**Office Addition  
Little Egg Harbor Municipal Utilities  
823 Radio Road, Little Egg Harbor, N.J.  
Addendum # 1  
May 11, 2026**

**Bid Package Clarification and Changes**

This Addendum dated May 11, 2026, for the Office Addition of Little Egg Harbor Municipal Utilities shall be included as part of the Contract Bid Documents. This Addendum shall supplement and clarify the current Contract Bid Documents.

DRAWING NUMBER  
**E-6**

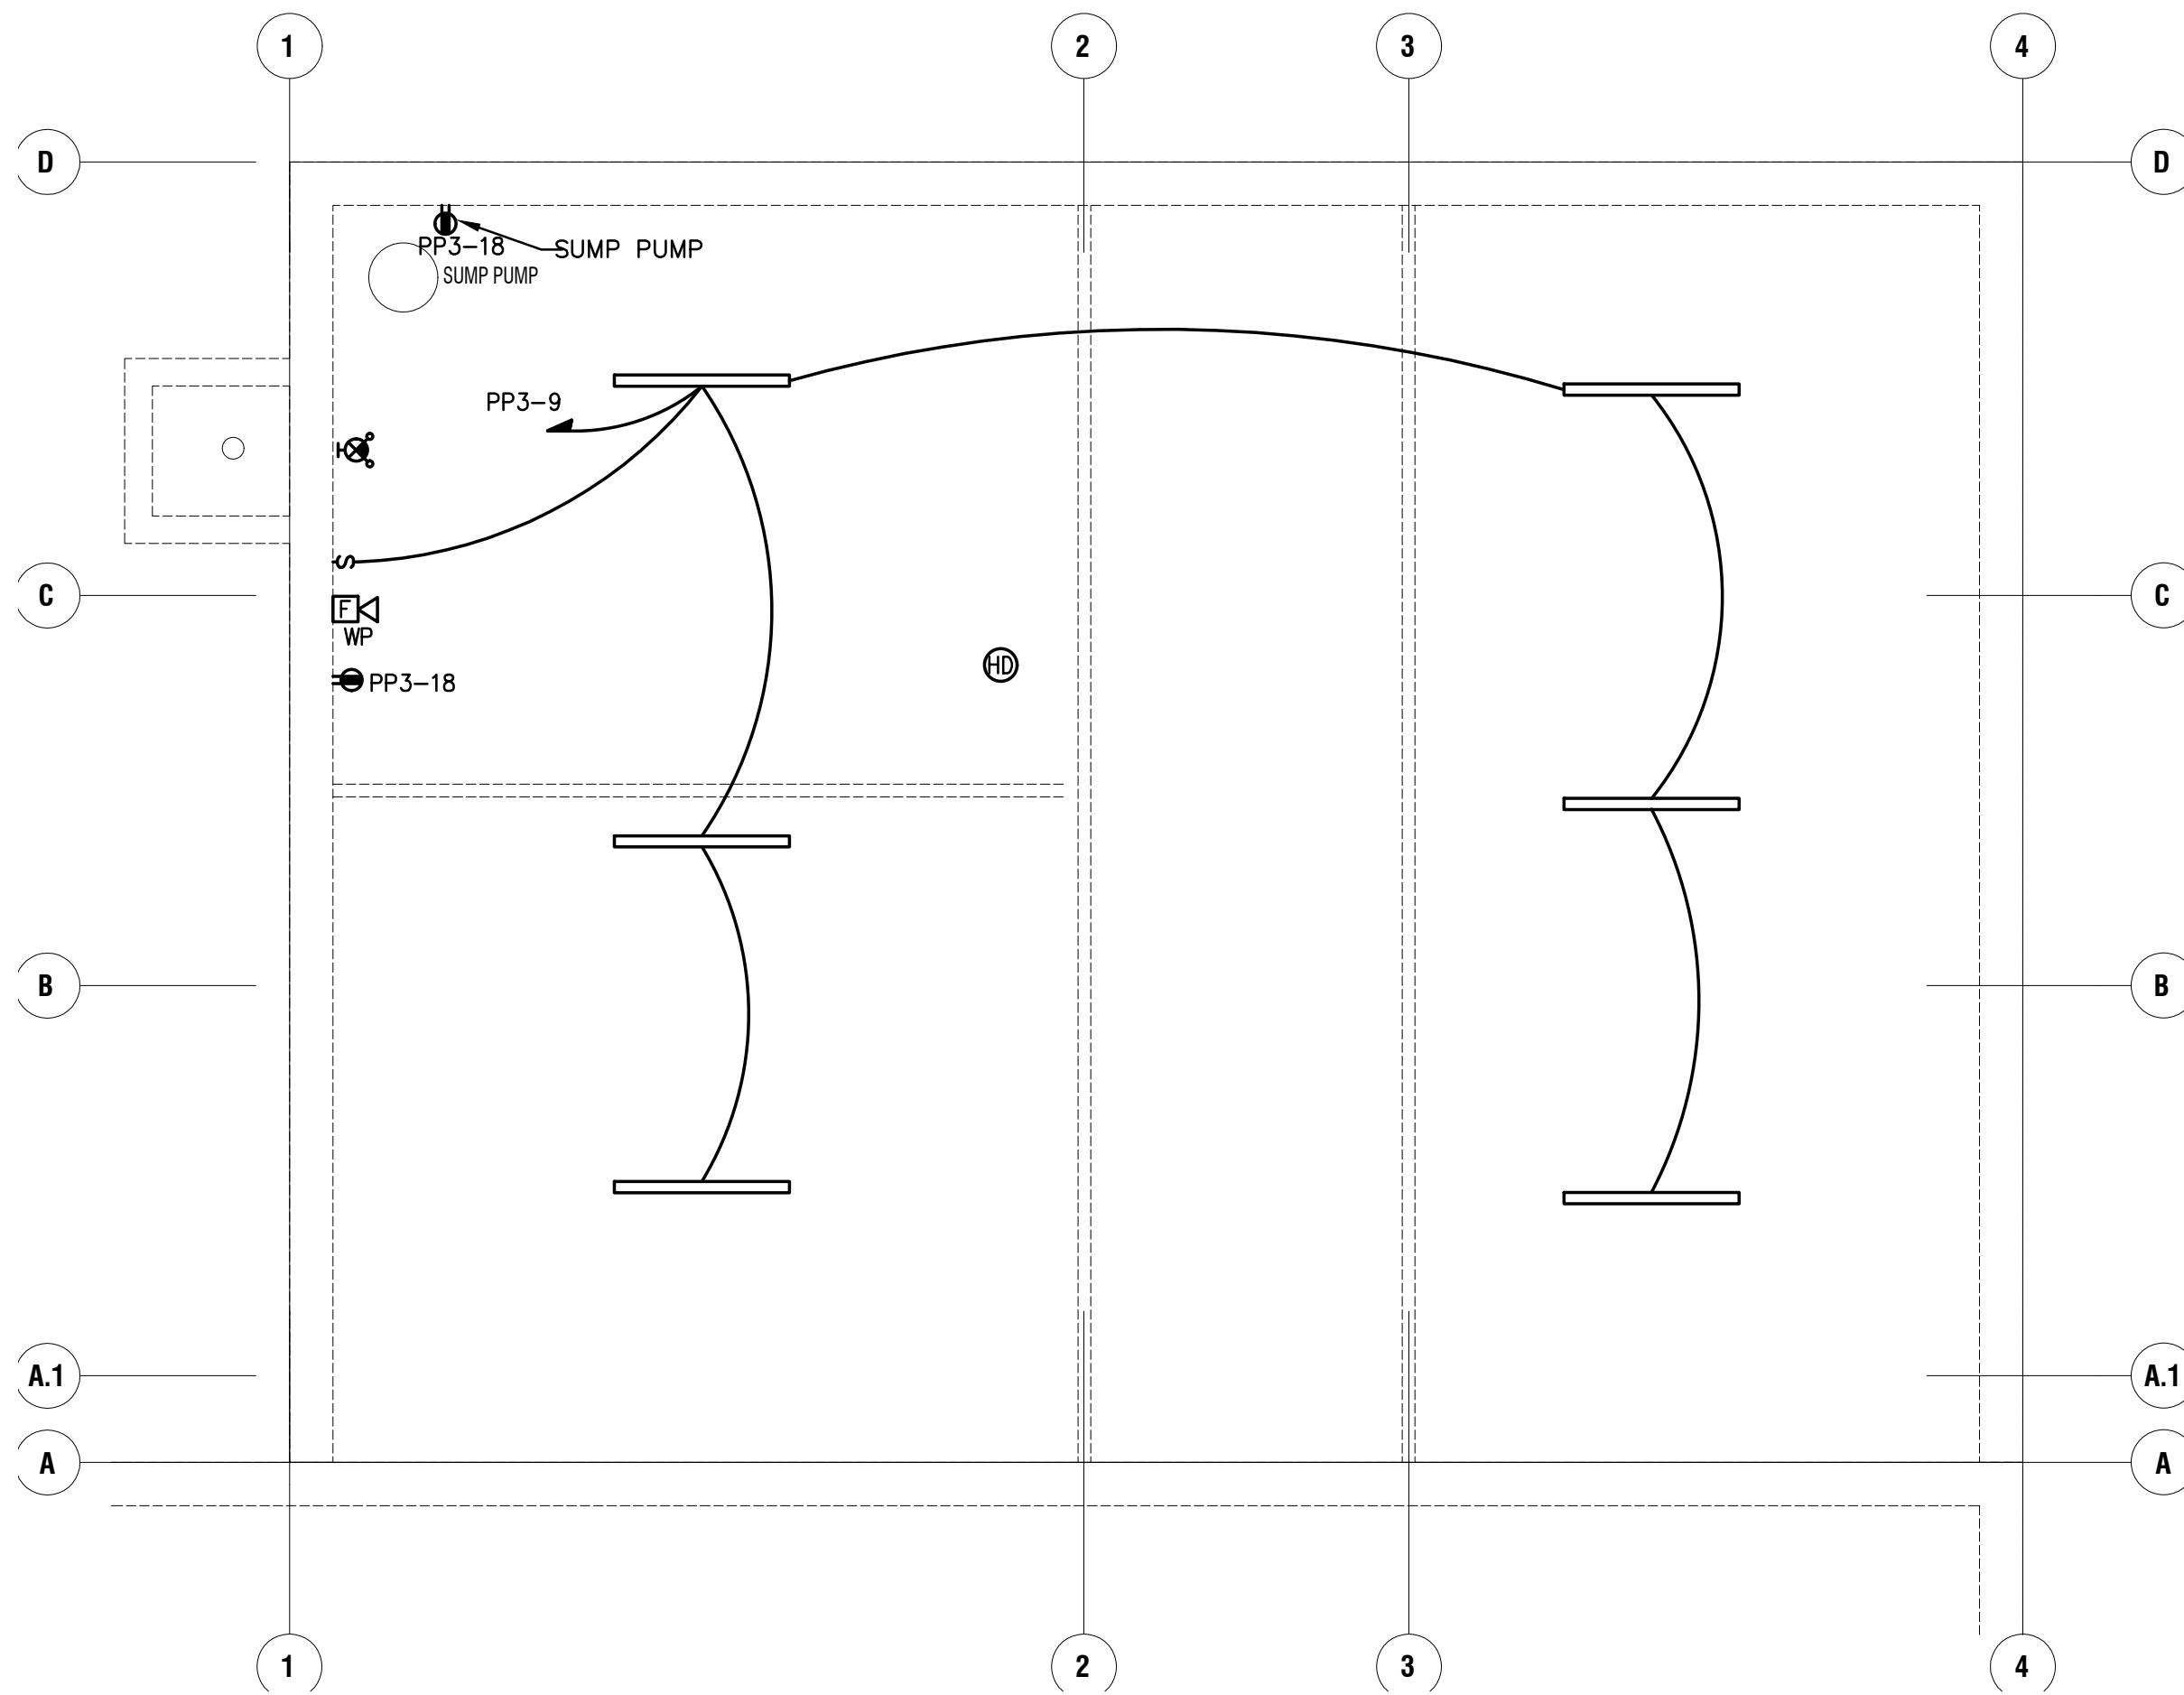
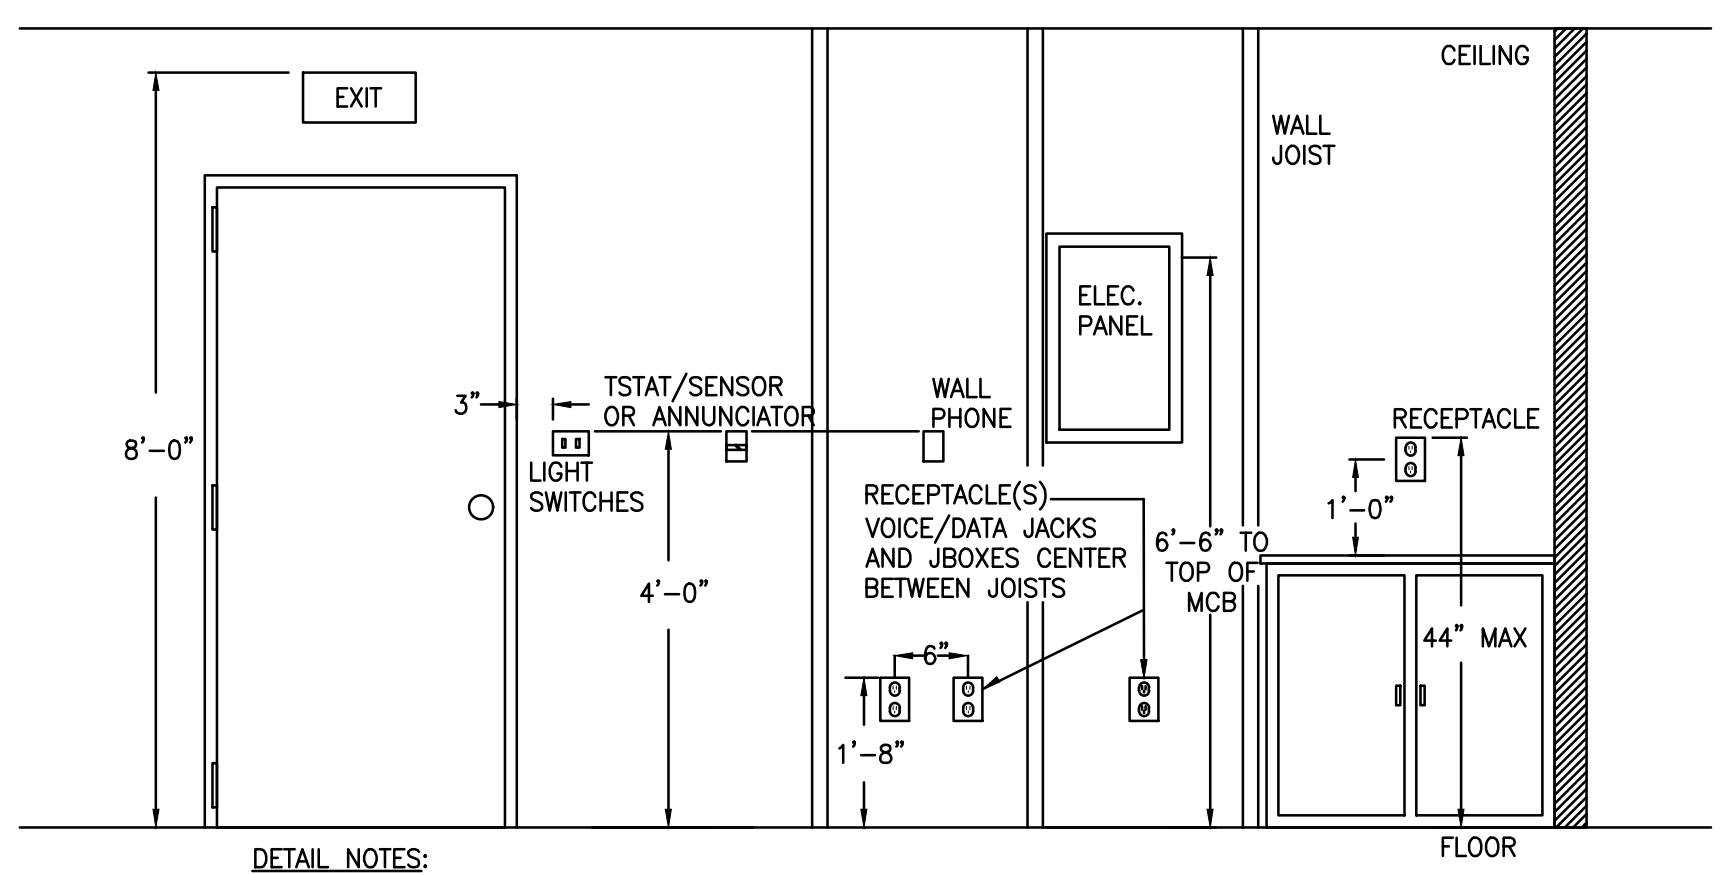
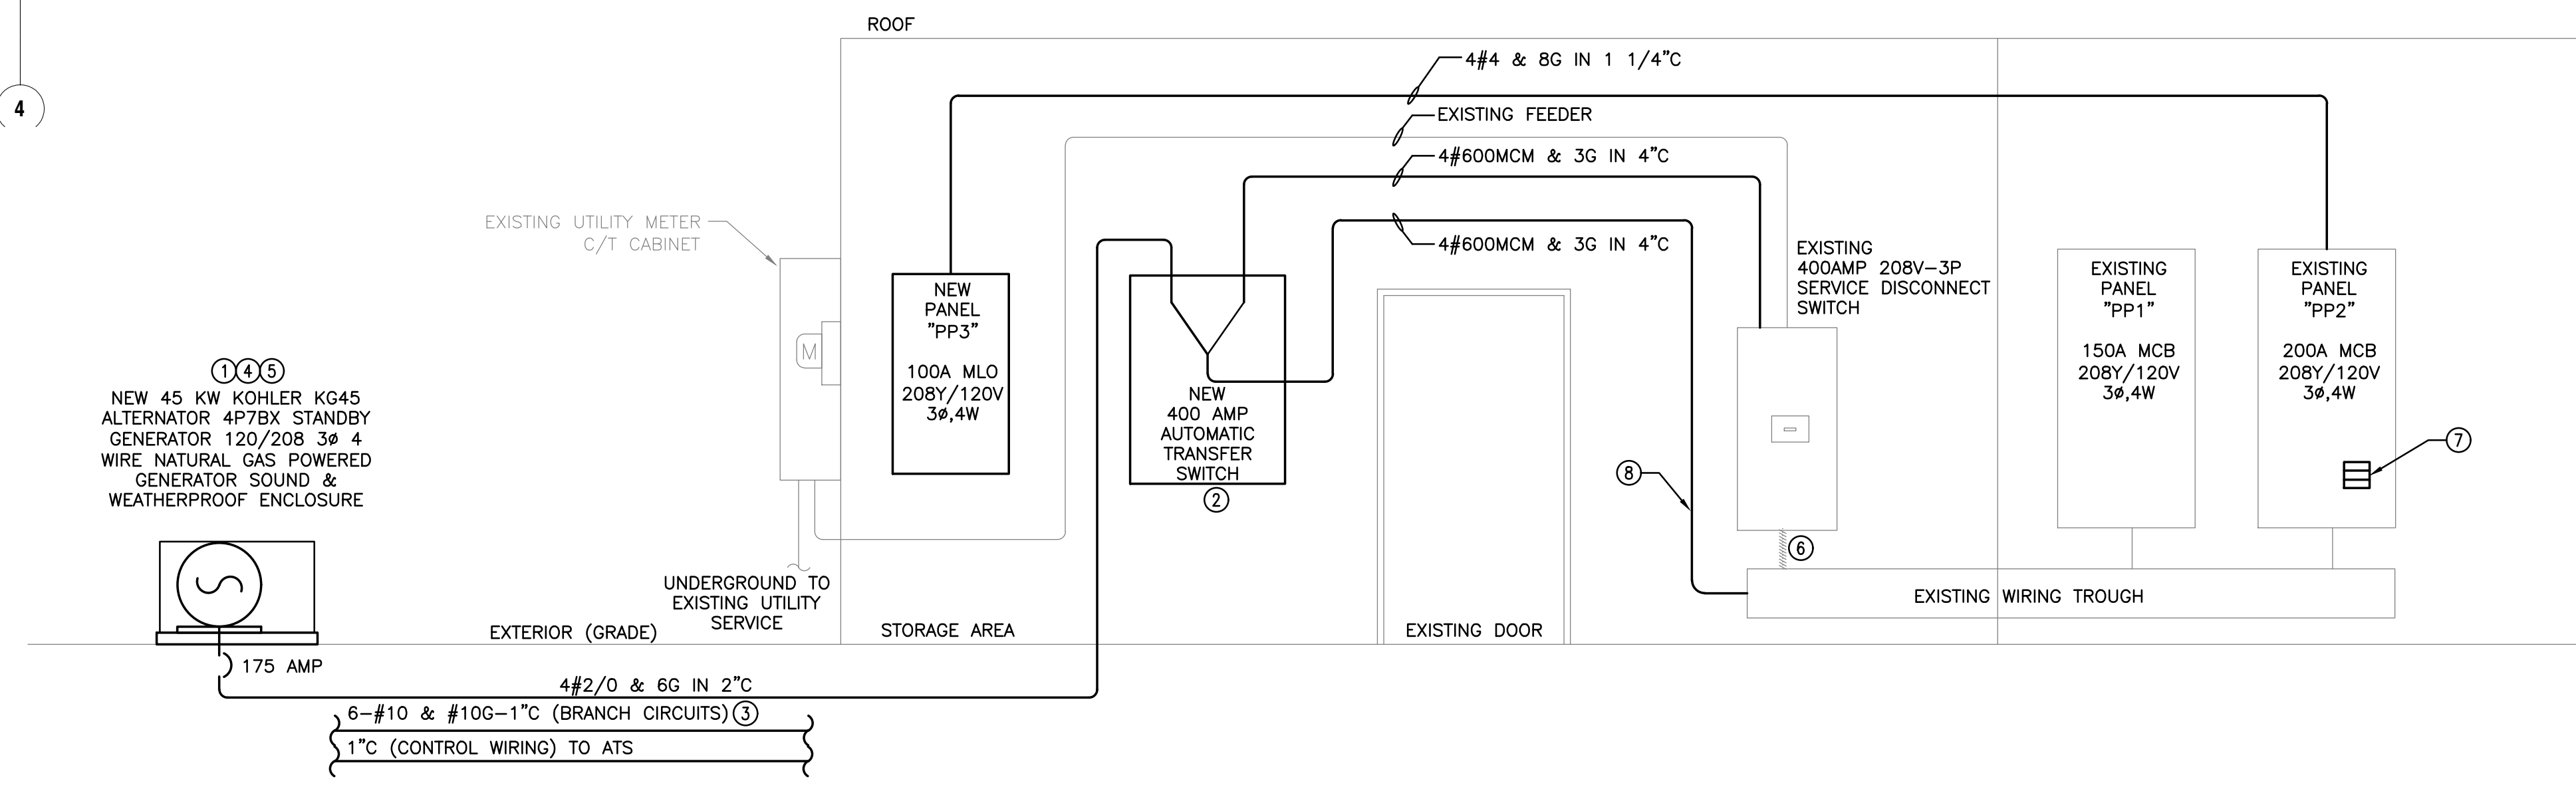
Refer to Revised Electrical Drawing See E-06, M-01

SHEET 1 OF 2  
 DRAWING NUMBER  
 M-1  
 BASE SHEET  
 FILE NUMBER 250610

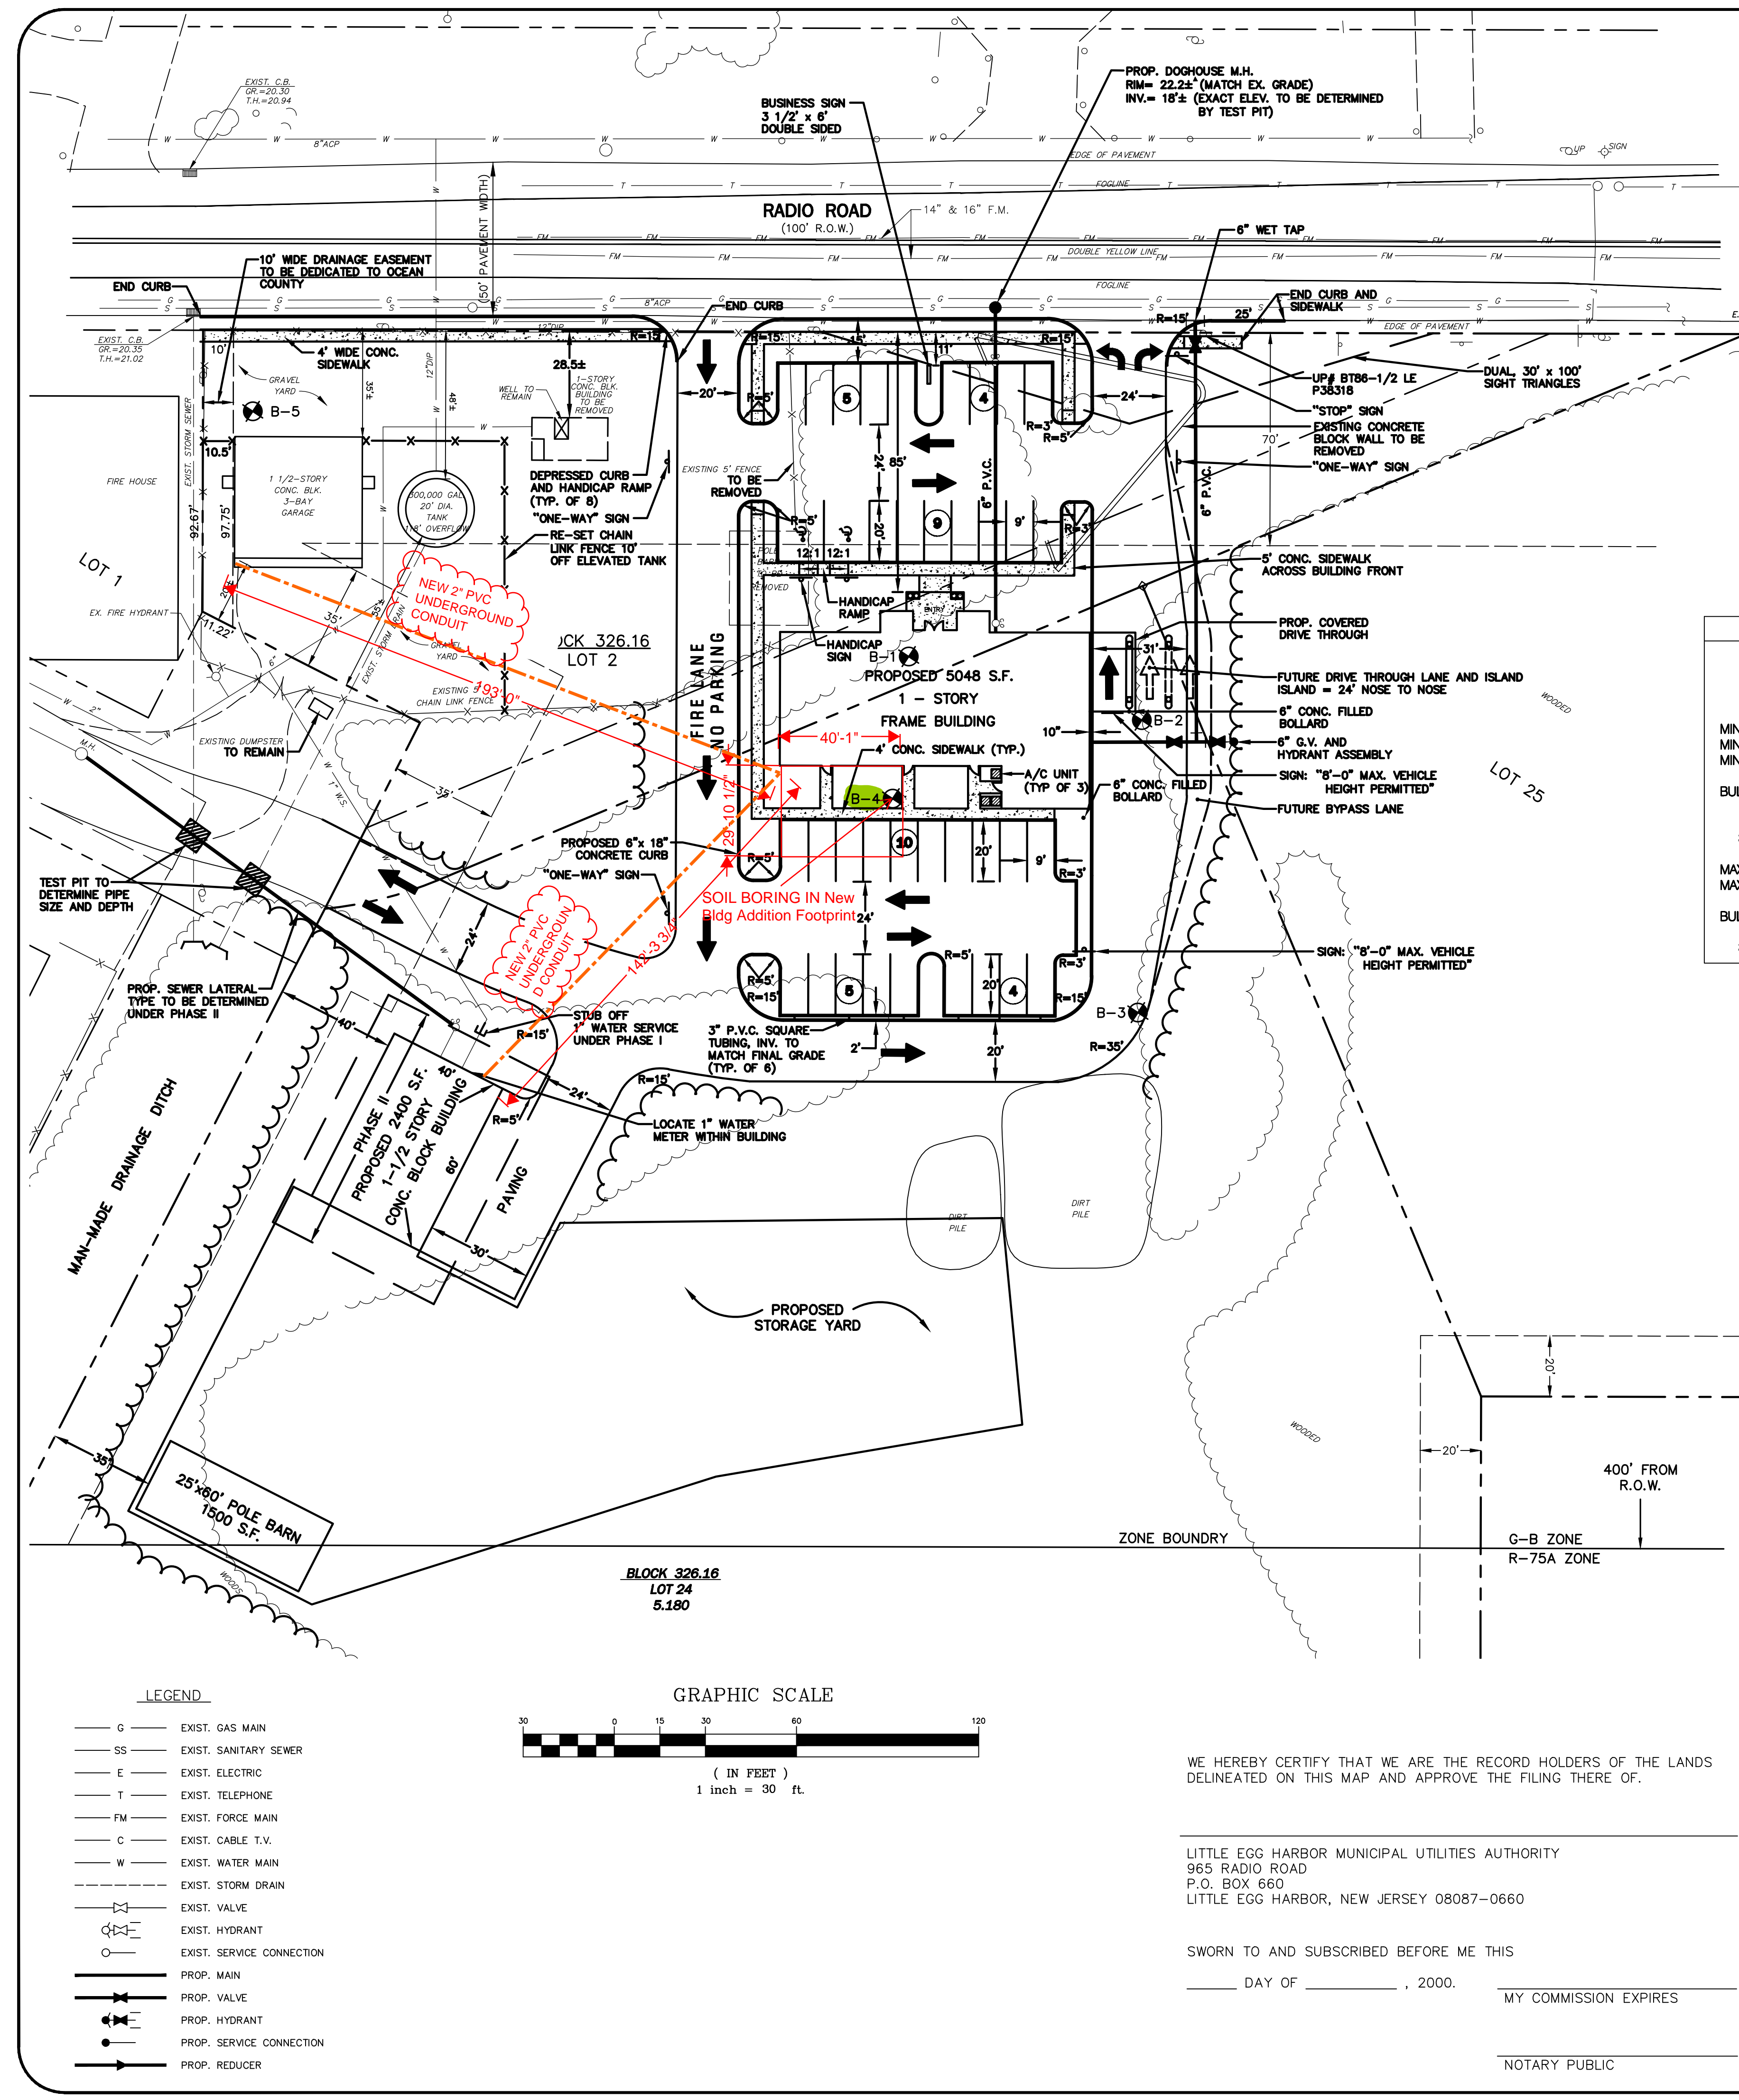
**23. New Split System Air Conditioning Unit addition to Network Room**

**SITE PLAN**

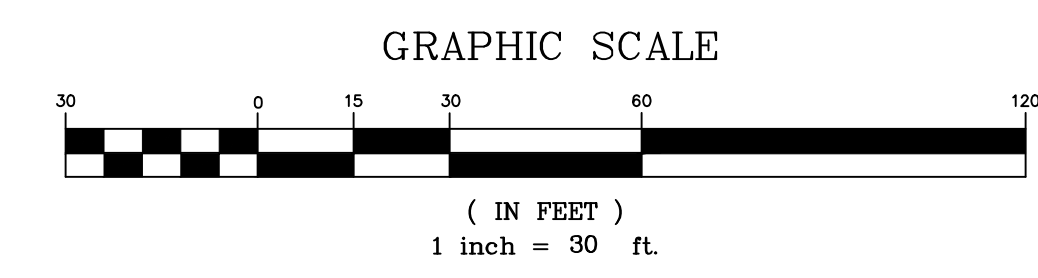
Install a separate new underground 2” PVC empty conduit with pull string from the new office addition crawl space to the two buildings shown on the Site Plan-Soil Boring Map. The conduit is to stub up four inches above the floor slab inside the building perimeter next to the exterior wall assembly. Co-ordinate final locations of stub up with owner. See E-03, Site Plan Boring Map
